GROUP 13A

MULTIPOINT FUEL INJECTION (MPI)

OUTLINE OF CHANGES

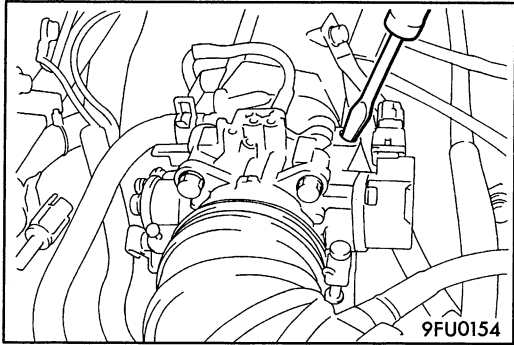
In connection with the disuse of the ignition timing adjusting connector, the following controls have been changed:

- From among the conditions in which the engine warning lamp should illuminate, the ignition timing adjustment signal has been deleted.
- Diagnosis code No. 36 <Ignition timing adjustment signal system> has been deleted.
- The ignition timing adjustment signal input to No. 52 terminal of the engine ECU has been deleted.
- The procedure for the basic idle speed adjustment has been changed as follows:

3. Start the engine and run at idle.
4. Select the item No. 30 of the MUT-II Actuator test.

This holds the ISC servo at the basic step to adjust the basic idle speed.
